# CITY OF PORTLAND

Permit Number: 081431

has permission to Restaurant - "Olive Cafe" - replace previously permitted signs permit #070178 install one (1) hanging sign & one (1) wall sign

AT 129 COMMERCIAL ST CBL 029 D001001

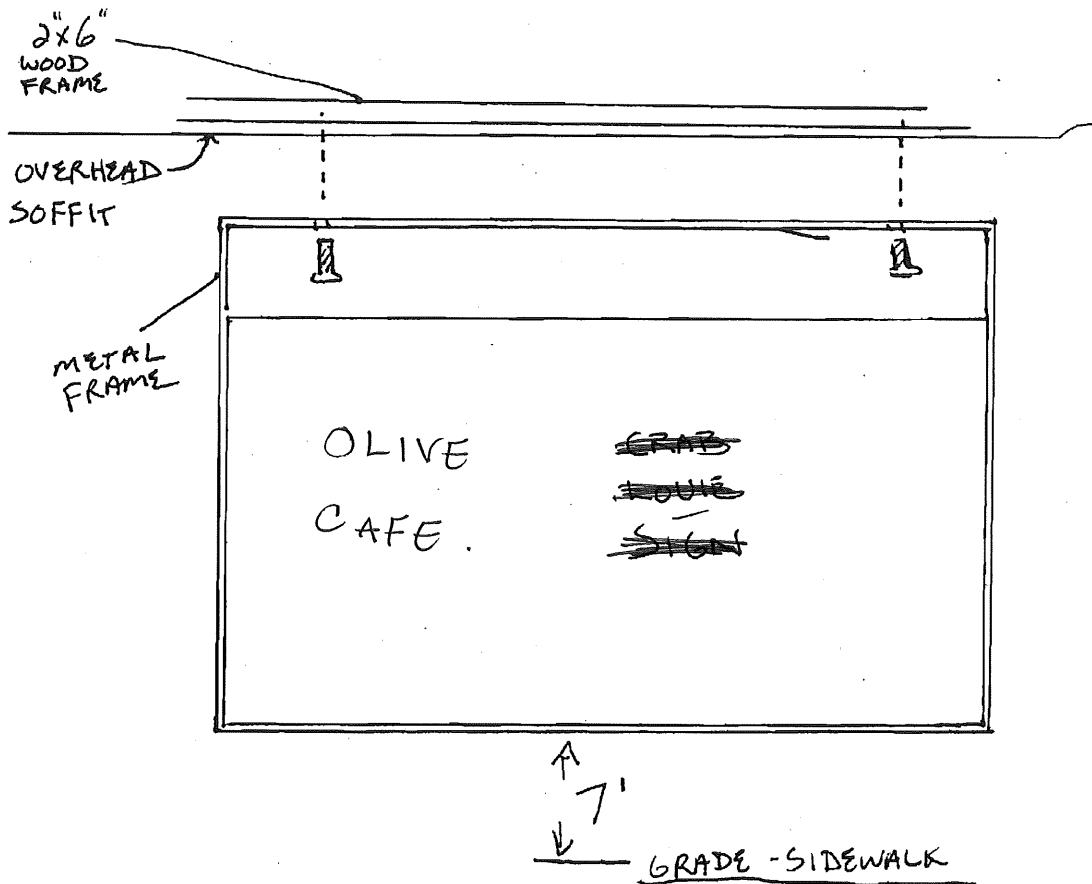
FRONT :  $36'' \times 52'' = 1872 \div 144 = 13$ .

BACK :  $36'' \times 52'' = 1872 \div 144 = 13$

A TWO SIDED LAMINATED SIGN ON WOOD. THE SIGN WILL BE ~~BE~~ ENCLOSED IN A METAL MOUNTING BRACKET AND ATTACHED OVERHEAD WITH 5/8 INCH GALVANIZED LAG BOLTS. THIS WILL BE MADE AND ATTACHED BY A PROFESSIONAL AND LICENSED SIGN MAKING COMPANY WHICH I WILL BE CONTRACTING IN THE NEAR FUTURE. THE SIGN WILL BE ILLUMINATED WITH EXISTING EXTERNAL OVER HEAD LIGHT THAT ARE CONTROLLED FROM INSIDE

## OLIVE CAFÉ SIDEWALK SIGN:

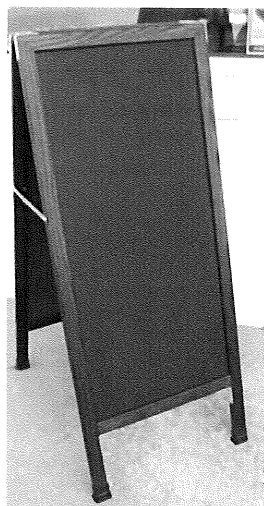
11/10/2008-amachado: Left voicemail for Rayan Elkhatib. Need drawing of the sidewalk sign showing the dimensions &amp; design work.

\* Approximate Size of Sign will be roughly 18" W x 42" H. <sup>max height 40" to top of sign in place.</sup>  
(See attached sign - this is what we want to have.)

1) Maximum height for the sidewalk sign is 40" to the top of the sign in place.			
2) All sidewalk signs shall be removed when the business is closed or while any snow or ice exists on the walkway within eight feet of the sign in any direction. All sidewalk signs shall be located near the curb rather than the building face. The sidewalk shall maintain a width of no less than 4 1/2 feet of unobstructed sidewalk width perpendicular to major flows. For a single tenant listing, the maximum width is 24 inches or less if needed for the 4.5 feet of unobstructed sidewalk width. The maximum height of a sidewalk sign is 40 inches to the top of the sign in place. The minimum height of a sidewalk sign is 30 inches to the top of the sign in place.
